# UNITED STATES PATENT AND TRADEMARK OFFICE

APPLICATION NO.	FILING DATE	FIRST NAMED INVENTOR	ATTORNEY DOCKET NO.	CONFIRMATION NO.
10/804,804	03/18/2004	Daniel J. Kane	70047-42-UT	8892
5179	7590	08/10/2005		
PEACOCK MYERS, P.C. P O BOX 26927 ALBUQUERQUE, NM 87125-6927			EXAMINER CONNOLLY, PATRICK J	
			ART UNIT	PAPER NUMBER
			2877

**Office Action Summary**

**FIG. 1**

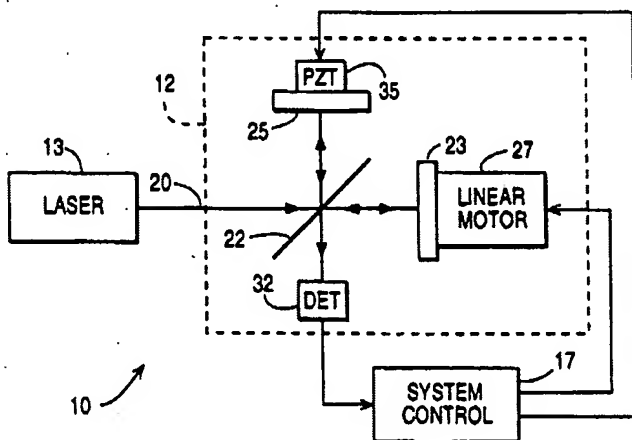
As to claims 1, 8, 9, 13-17, 23-25 and 29-32, Curbelo discloses a method and apparatus for Fourier transform spectrometry including (see Figure 1 below):

a dithering element by way of a piezo translator, \*providing a continuous relative phase shift between the two arms of the interferometer (35, 17, see also columns 5 and 6);

a detector providing, synchronous, lock-in detection (32, 17, see also Figure 2, columns 5 and 6).

As to claims 2 and 18, Curbelo teaches a laser source for interferometry as shown above in Figure 1.
